The Rothemere American Institute
 South Parks Road
 Oxford

South Elevation
 Grids 3-7
 Garden Level to entrance level.

DRAWING No: GA008 REV. 3

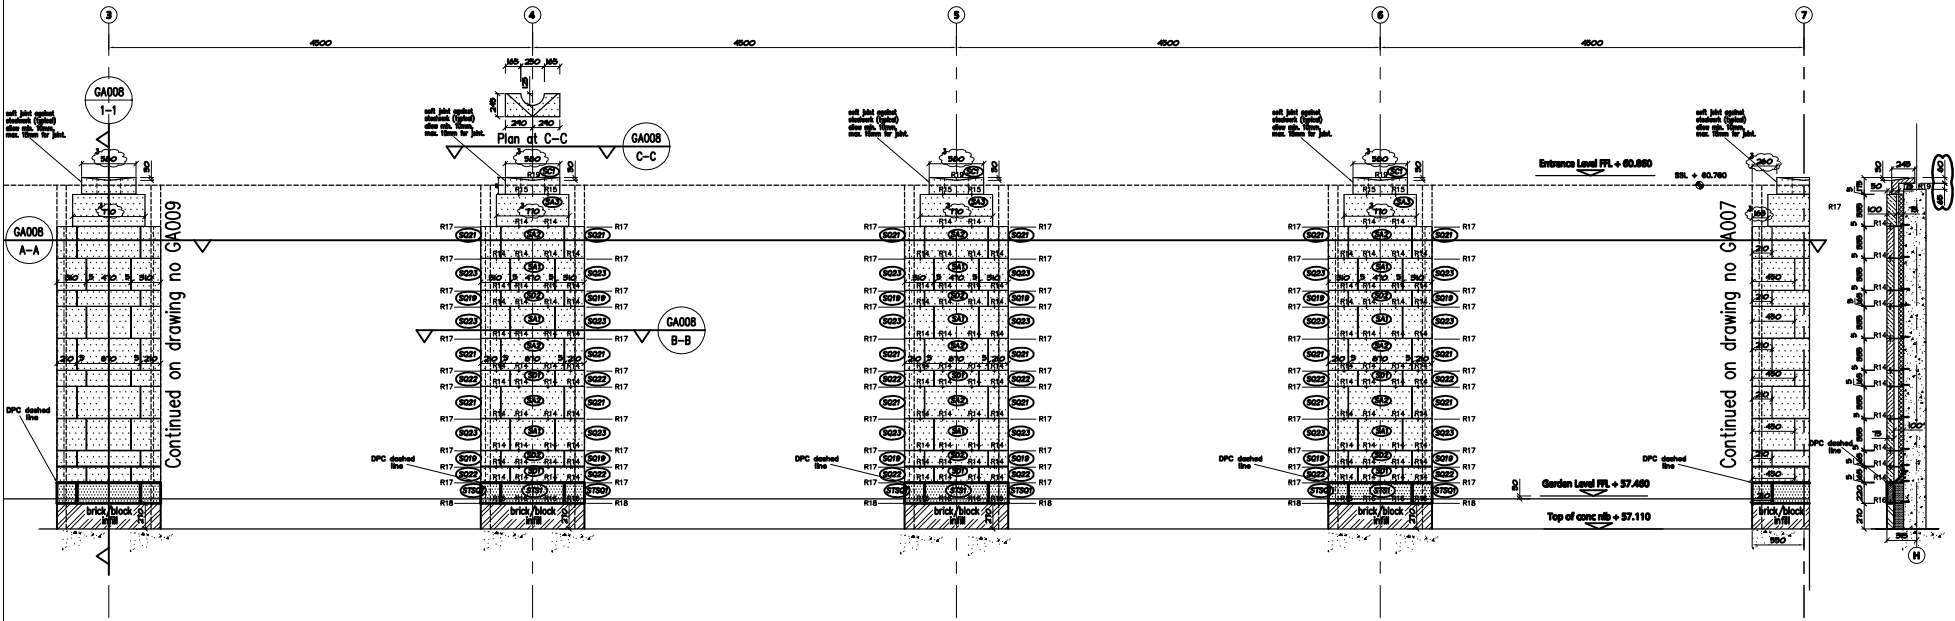
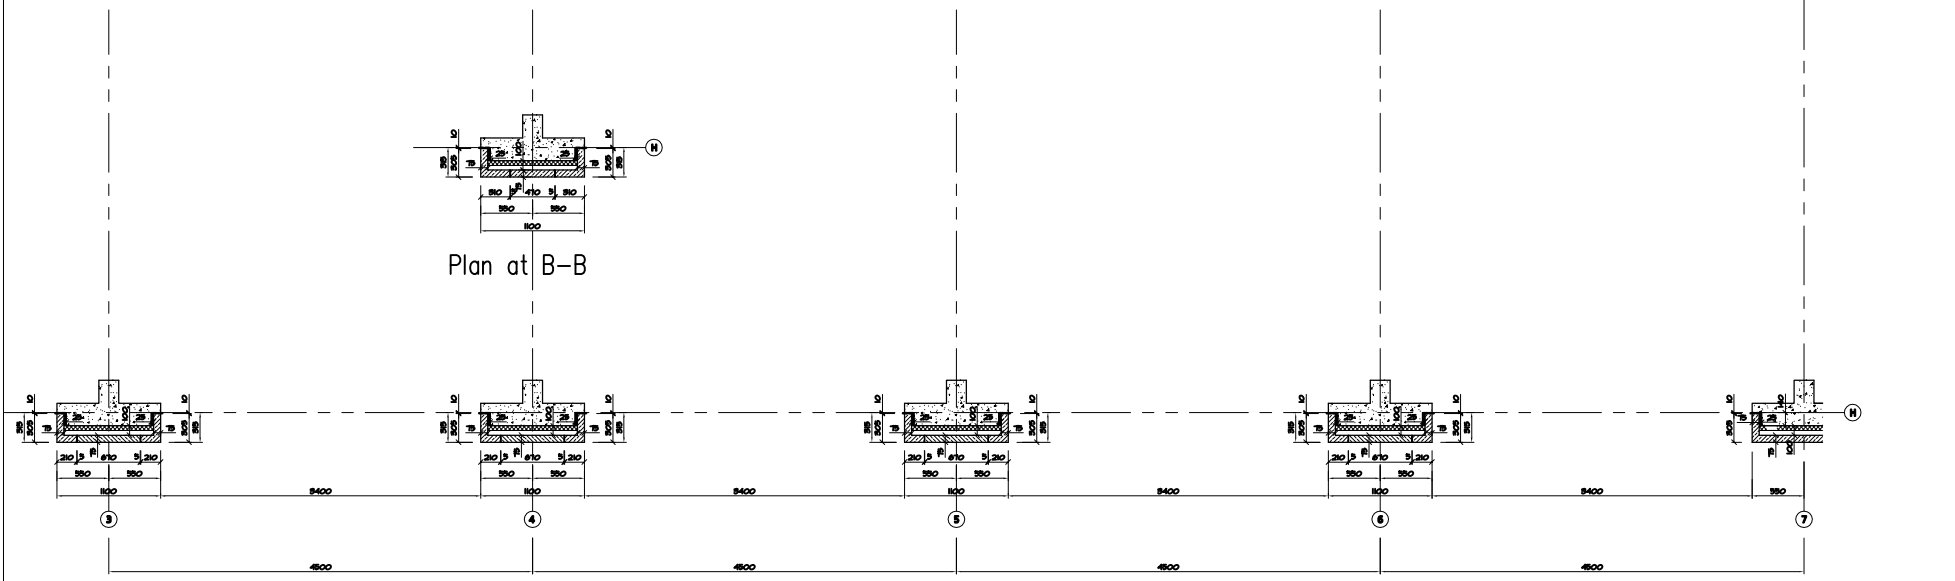
| 3 | 27.1.00 | Pier caps revised in accordance with Architects fax dated 10.1.00 |
| 2 | 19.11.99 | Hole in top of column stones numbered Sc1 increased to 125mm radius in accordance with Architects telephoned instruction on 17.11.99 |
| 1 | 16.8.99 | Revised in accordance with Architects returned and marked up drawings. Filings, DPC's and insulation added. |
